S1C17 Family Technical Manual Errata

S1C17 Manual errata

P26-1(S1C17711)

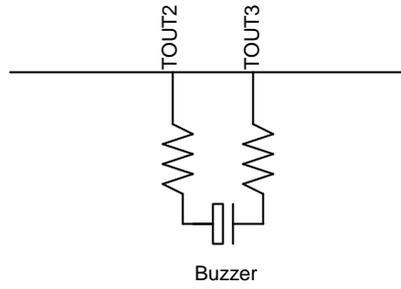
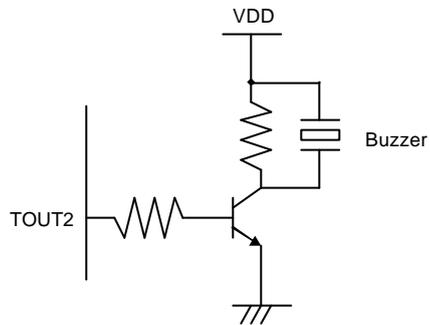
ITEM: Basic External Connection Diagram		
Object manuals	Document code	Object number
S1C17705	411706600	P26-1
S1C17711	411905600	P26-1
S1C17121	411723700	P29-1
S1C17601	411805700	P29-1
S1C17611	411882300	P29-1
S1C17621/602/622/604/624	411914900	P30-1
P26-1(S1C17705)		
<p>(Error)</p> <div style="text-align: center; margin: 10px 0;"> </div>		
<p>(Correct)</p> <div style="text-align: center; margin: 10px 0;"> </div>

(Error)

(Correct)

P30-1(S1C17621/602/622/604/624)

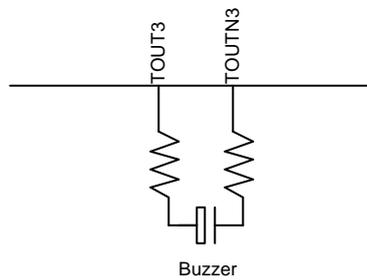
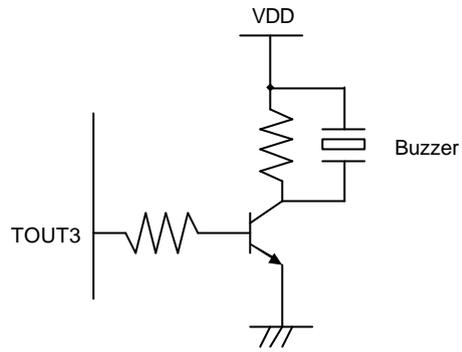
P29-1(S1C17121, S1C17601, S1C17611)

(Error)

(Correct)

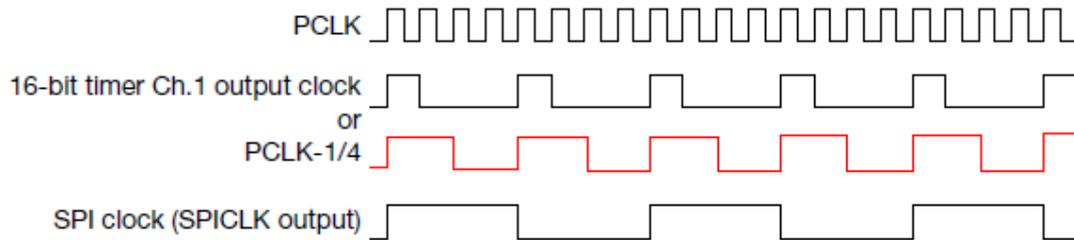
ITEM: SPI Clock		
Object manuals	Document code	Object number
S1C17121	411723700	P19-3
S1C17702	411581700	P19-3
S1C17003	411635100	P19-3
S1C17601	411805700	P19-3
S1C17611	411882300	P19-3
S1C17705	411706600	P15-2
S1C17621/S1C17602/S1C17622/ S1C17604/S1C17624	411914900	P19-3
P19-3(S1C17602,S1C17121,S1C17702,S1C17003,S1C17601,S1C17611)		
<p>(Error)</p> <p>The Master mode SPI uses the internal clock output by the 16-bit timer Ch.1 as SPI clock. This clock is output from the SPICLK pin to slave device while also driving the shift register. Use the MCLK(D9/SPI_CTL register) to select to use the 16-bit timer ch.1 output clock or PCLK-1/4 clock. Setting MCLK to 1 selects the 16-bit timer Ch.1 output clock; setting to 0 selects to 0 selects the PCLK-1/4 clock.</p> <p>*MCLK: SPI Clock Source Select Bit in the SPI Control(SPI_CTL)Register(D9/0x4326)</p> <p>Using the 16-bit timer Ch.1 output clock enables programmable transfer rates. For more information on 16-bit timer control, see "11 16-bit Timer(T16)."</p> <p>The diagram shows three digital signals over time. The top signal, labeled 'PCLK', is a high-frequency square wave. The middle signal, labeled '16-bit timer Ch.1 output clock or PCLK-1/4', is a square wave with a frequency approximately one-fourth that of PCLK. The bottom signal, labeled 'SPI clock (SPICLK output)', is a square wave with a frequency approximately one-fourth that of the middle signal.</p>

The Master mode SPI uses the internal clock output by the 16-bit timer Ch.1 as SPI clock. This clock is output from the SPICLK pin to slave device while also driving the shift register. Use the MCLK(D9/SPI_CTL register) to select to use the 16-bit timer ch.1 output clock or PCLK-1/4 clock **is used**. Setting MCLK to 1 selects the 16-bit timer Ch.1 output clock; setting to 0 selects the PCLK-1/4 clock.

*MCLK: SPI Clock Source Select Bit in the SPI Control(SPI_CTL)Register(D9/0x4326)

Figure 15.3.1 Master Mode SPI Clock

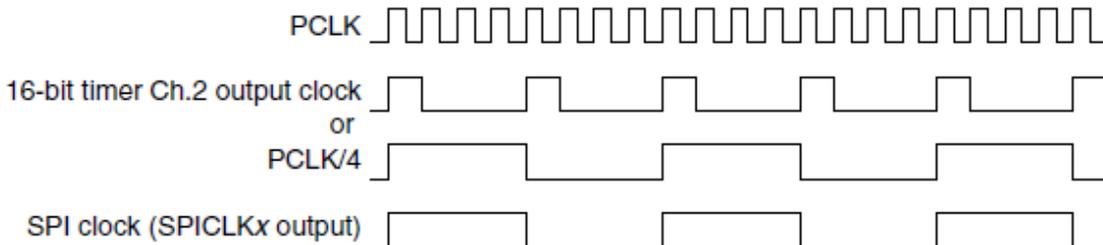
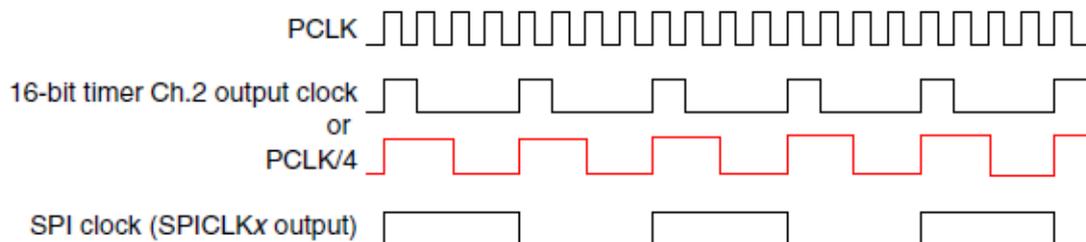
P15-2(S1C17705)

(Error)

(Correct)

Figure 19.3.1 Master Mode SPI Clock

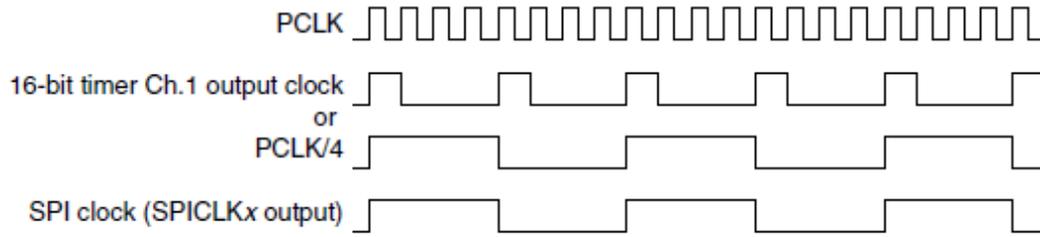
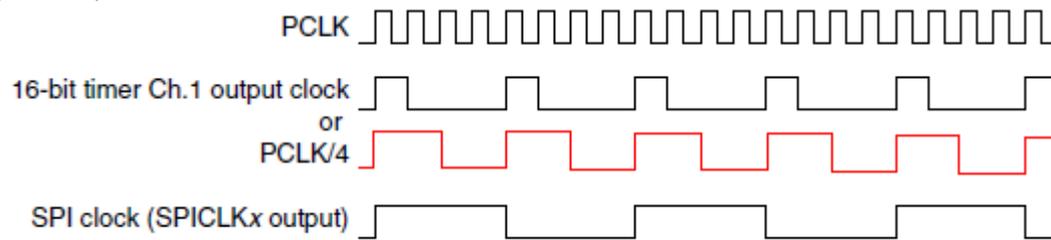
P19-3(S1C17621/S1C17602/S1C17622/S1C17604/S1C17624)

(Error)

(Correct)
